Post Exhibition - Planning Proposal - 2 Chifley Square, Sydney - Sydney Local Environmental Plan 2012 and Sydney Development Control Plan 2012 Amendment

File No: X038910

Figure 7: Requested change to eastern setback of planning envelope

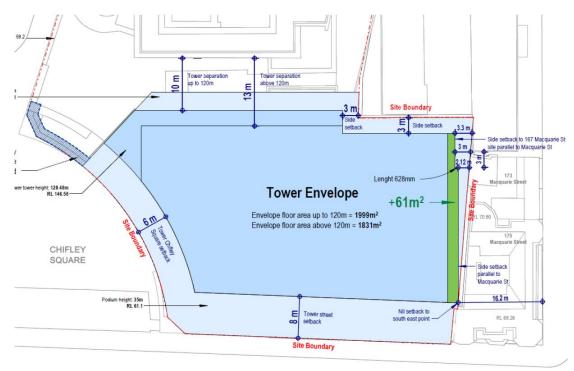
- 42. The proponent, Charter Hall, requested a reduction of the eastern setback of the planning envelope, from 2m 4.7m to 0m 3.3m, as shown in the plan at figure 7 below. The change is not supported for the reasons discussed below.
- 43. The additional area of the envelope resulting from the requested reduced setback is depicted in green:

- 44. The plan shows this reduction in setback would result in an additional 61sqm of floor area, or a total increase 1,026sqm for the whole planning envelope, although this does not factor in building efficiency and articulation allowances.

- 45. The Central Sydney planning controls allow for setbacks to be reduced subject to there being no overall reduction in amenity (wind and sky view) in public places, and that urban design outcomes are still achieved. The request to reduce the eastern setback was accompanied by sky view factor and wind reports, to demonstrate that the proposed envelope would result in a better outcome in the public domain compared to the base case envelope.

- 46. Urban design and heritage impacts were a key consideration in the assessment of a suitable planning envelope on this part of the site. In response to concerns raised by the Design Advisory Panel (DAP) about the original proposed envelope, a DAP subcommittee was formed. One of the key issues considered were setbacks, including tower envelope setbacks to the eastern boundary to provide for appropriate building separation, and separation of massing to the two local heritage items at 171-173 and 175-181 Macquarie Street known as 'Horbury House' and 'Wyoming'. The eastern setback of the planning envelope was also established to be sympathetic to the building alignment in Macquarie Street, and provide for a built form to support attractive streetscapes with high amenity. The 2 metre setback was seen as a minimum, as the DAP subcommittee had given consideration to an even greater setback to Macquarie Street for urban design and amenity outcomes.

- 47. Macquarie Street has important heritage significance, as it includes local, state, and world heritage items, and is included in the Macquarie Street Special Character Area. In addition, the Federal Government has proposed to include the Governors' Domain and Civic Precinct as part of the National Heritage List. This listing is proposed to include Macquarie Street, and Horbury House in particular. Part of the significance of this precinct is the development of Macquarie Street with its early colonial architecture as important milestones in the creation this distinctive civic precinct, with later buildings within the precinct continuing to respect the inherited civic intentions for this area. It is therefore considered that the setback of the planning envelope as exhibited should be retained in order to respect these important heritage considerations.

- 48. Although the owner of the property at 175-181 Macquarie Street, known as 'Wyoming' provided a submission supporting the reduced setback and advising they would support an easement for maintenance, it is not considered to outweigh the urban design and heritage impacts that would result from a reduced or nil setback from a heritage item.

Figure 8: Photo from the Investa submission with estimated view loss from 60 Martin Place

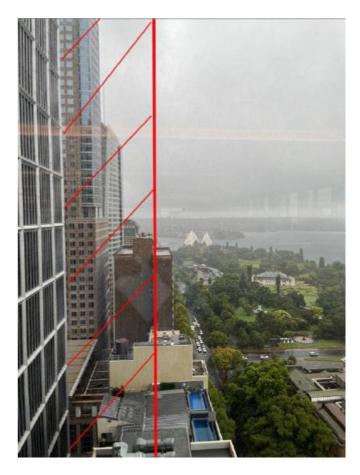
- 49. A submission was received from the owner of 60 Martin Place raising concerns that the eastern setback of the planning envelope approved by the Central Sydney Planning Committee and Council, of 2m 4.7m should be increased to comply with the DCP requirement of 6.5m, and have chamfered corners, due to impacts on view loss from 60 Martin Place. The submission included a photo from level 21 of 60 Martin Place, at Figure 8, with the approximate extent of the proposed envelope shown, and potential view loss extent in red hatched area.

- 50. The Central Sydney Planning Strategy allows for setbacks to be reduced subject to there being no overall reduction in amenity (wind and sky view) in public places, and that urban design outcomes are still achieved. The proposed envelope did not require chamfered corners due to the sky view and wind testing of the envelope resulting in an improvement on the base case envelope, satisfying the requirements of the DCP.

- 51. The Central Sydney Planning Strategy prioritises views from public places but does not protect views from private places. Protecting private views in Central Sydney would constrain reasonable development that would help achieve the economic objectives for Central Sydney due to the density and heights of buildings.

Figure 9: Comparison of existing and potential view extents westwards from 60 Martin Place, Sydney

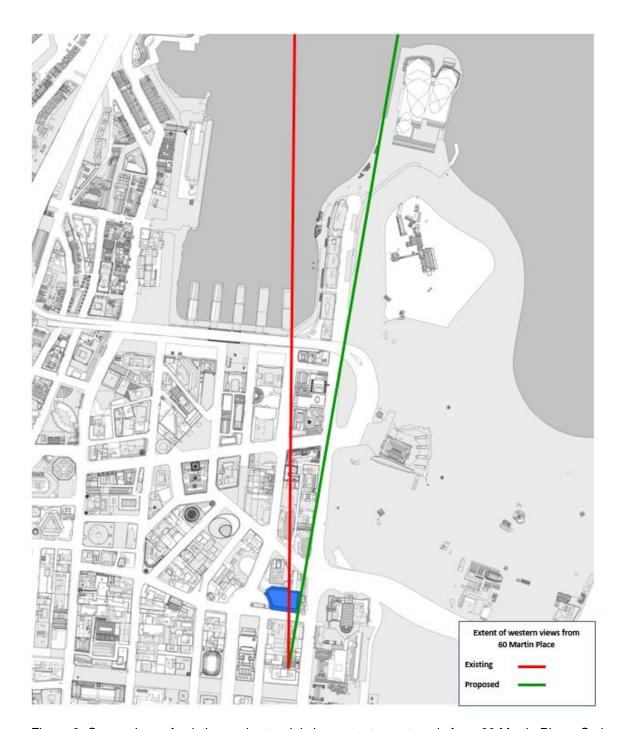
- 52. The City's analysis of the existing and potential views from 60 Martin Place is at Figure 9. The existing views in a northerly and westerly direction from the location indicated in the submission are restricted by existing buildings including Chifley Tower, Deutsche Bank Place at 126-144 Phillip Street, and the building at 167 Macquarie Street. Although it is acknowledged that a small portion of existing views would be impacted by the proposed planning envelope, extensive scenic views of the Sydney Opera House, The Domain, the Harbour and distant views eastwards would be retained. The loss of views from 60 Martin Place are not considered to warrant an even greater setback to the eastern boundary than that endorsed by CSPC and Council.

- 53. It is also noted that the planning proposal and draft DCP provide an envelope that a future building will be contained within. The final tower form will be established through the architectural design competition.
